INDIANTOWN COGENERATION PROJECT

SITE CERTIFICATION APPLICATION SUFFICIENCY RESPONSES

April 1991

INDIANTOWN COGENERATION L.P.'S
NOTICE OF FILING RESPONSES TO
SUFFICIENCY QUESTIONS OF
THE DEPARTMENT OF ENVIRONMENTAL REGULATION
AND OTHER AGENCIES

Exhibit FDER1-4

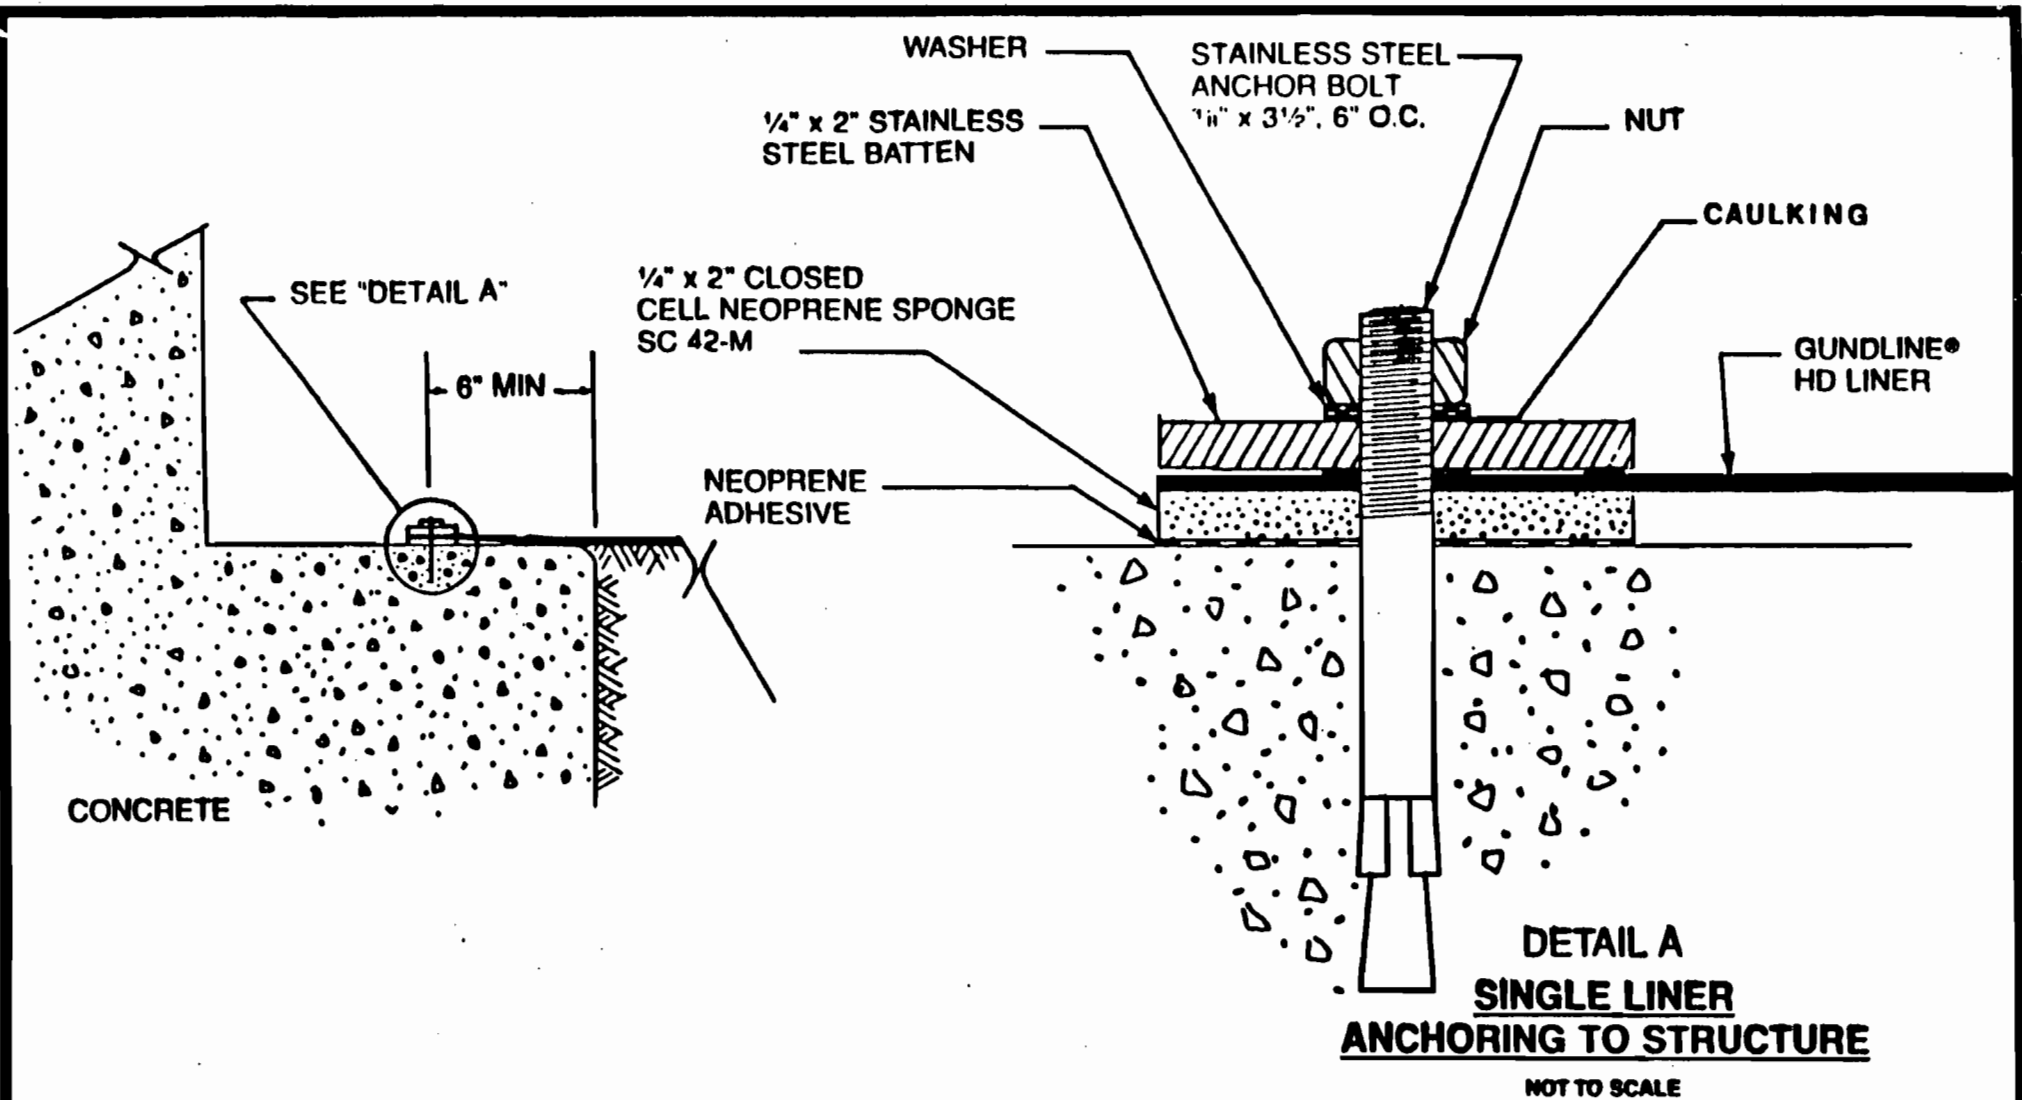
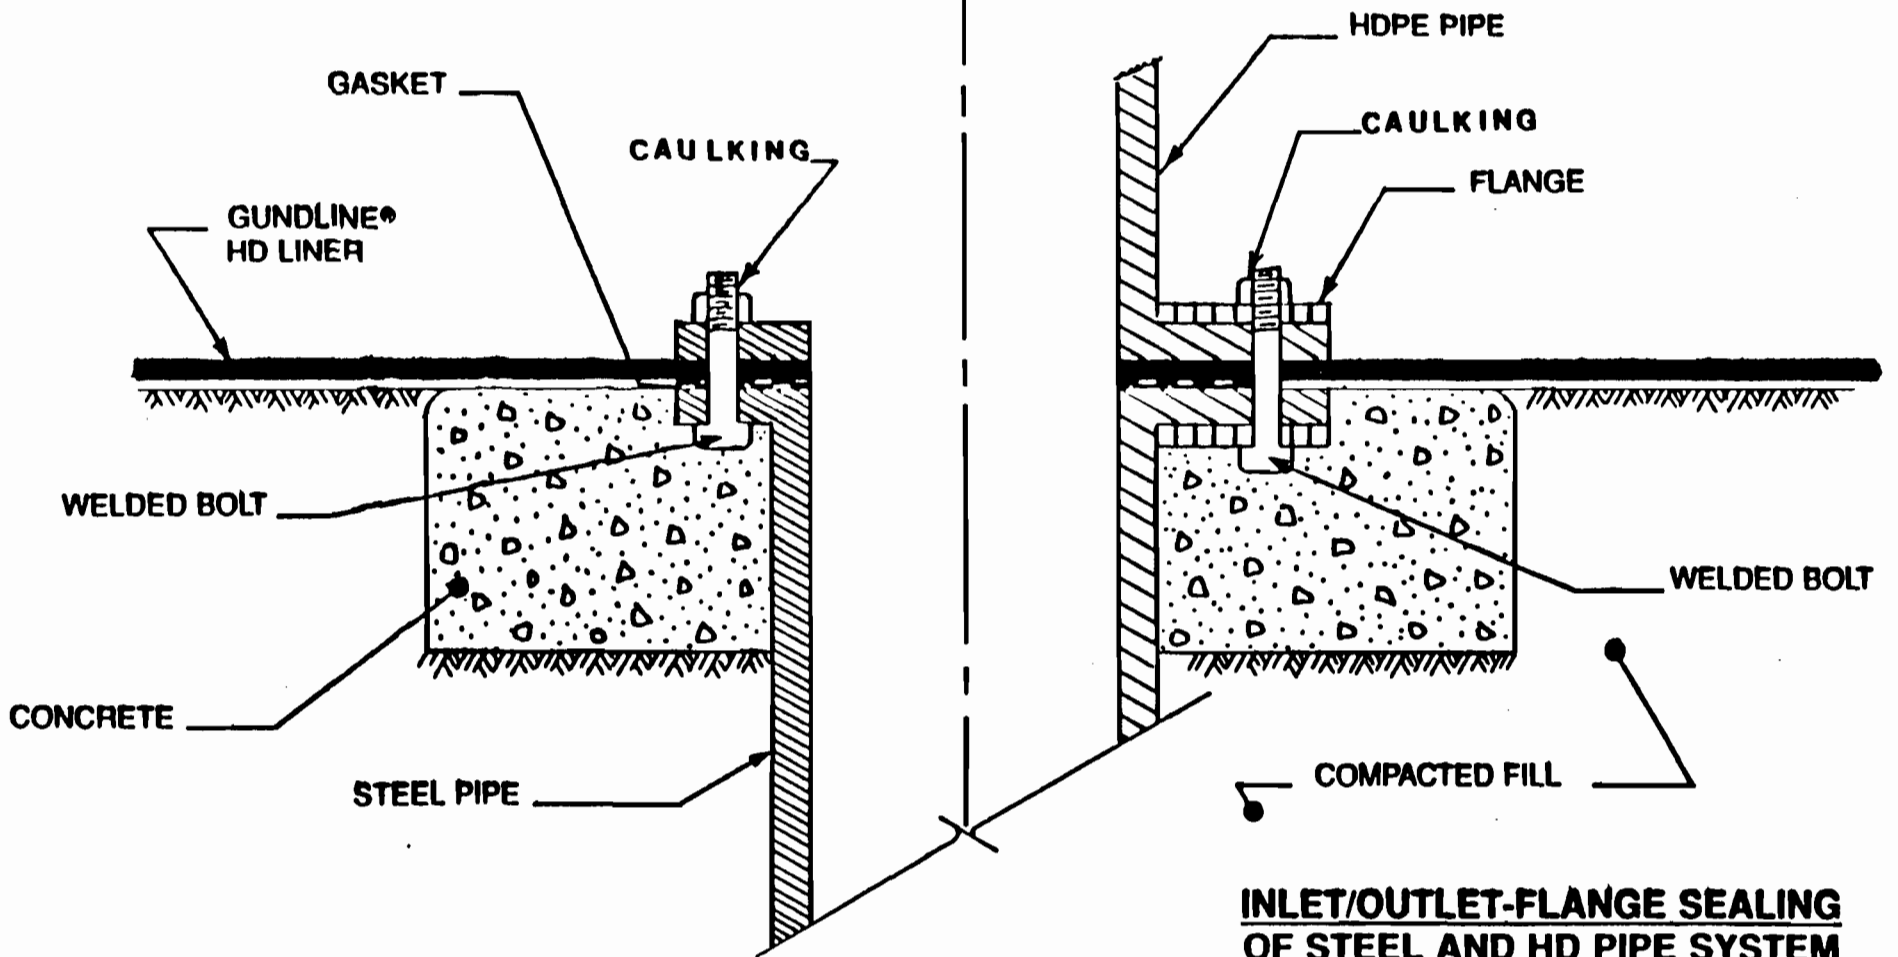
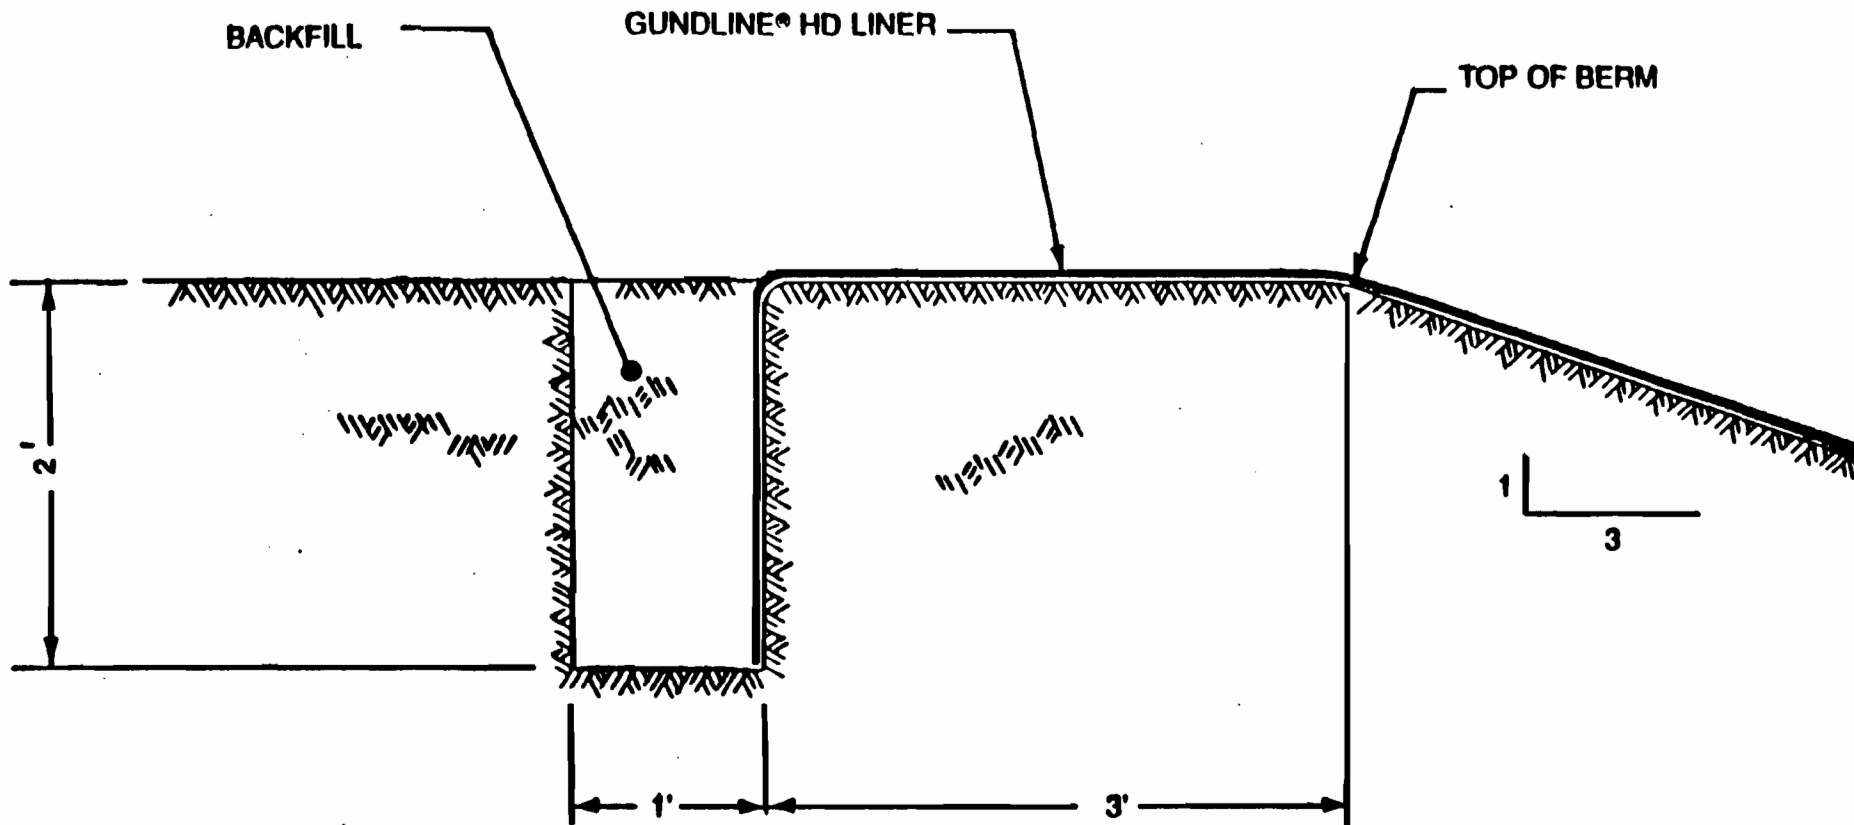
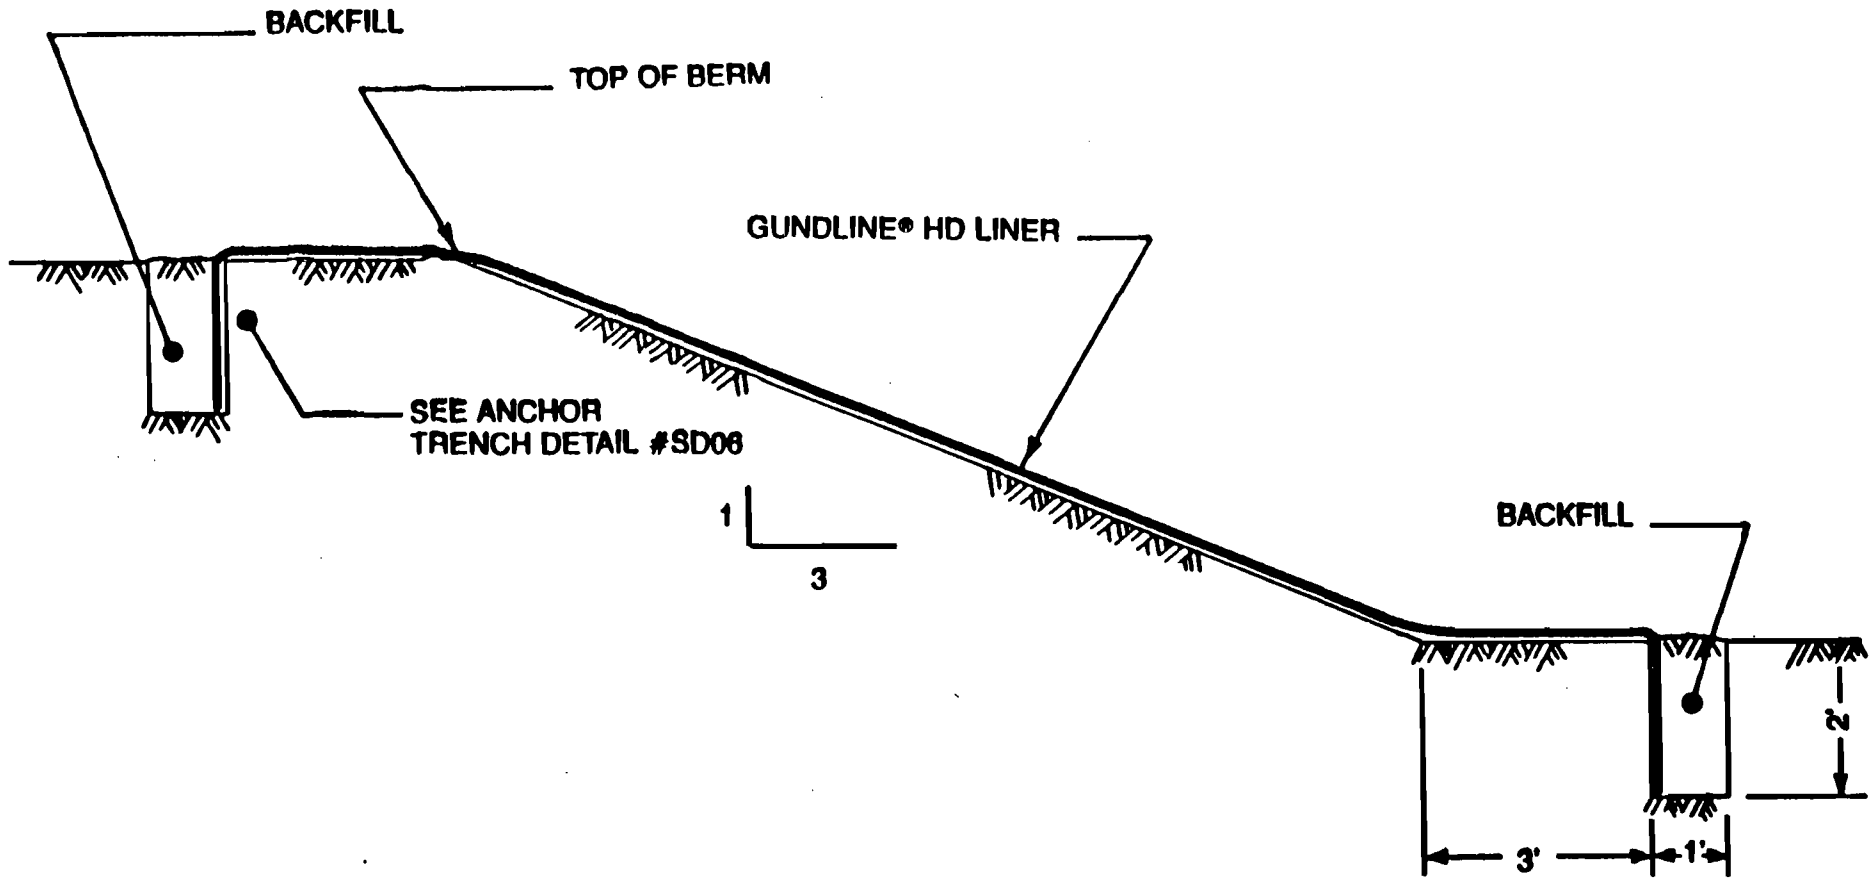
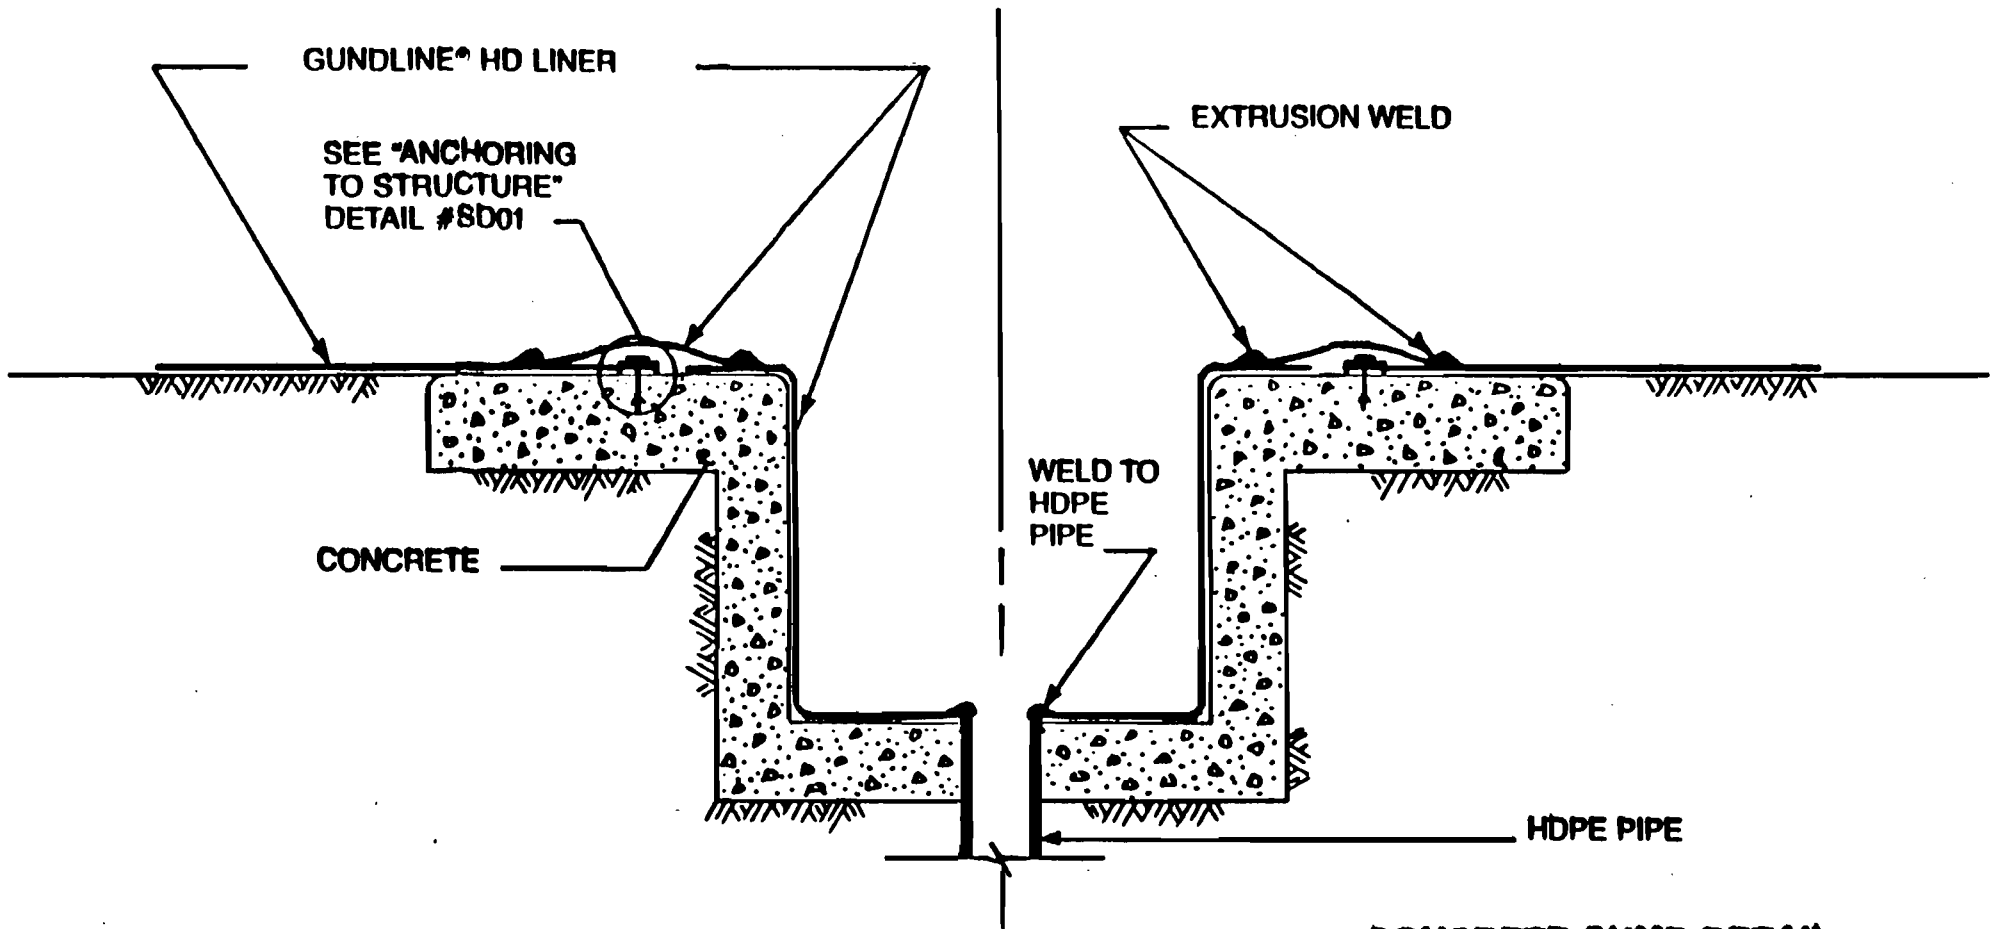
There were no construction specifications or drawings included with the application, e.g. no detail on liner construction for the cooling water storage pond, coal storage areas or run-off treatment basin.

The typical details of the anchoring of the liner to the structure, connection of inlet/outlet flange sealing of steel and HD pipe system, anchor trench detail, side slope protection, concrete sump detail, attaching liner to concrete structure, liner blow-out prevention, V-anchor trench, and typical wedge weld detail are shown on the attached detail sheets of Gundle Lining system (Exhibit FDER1-4).
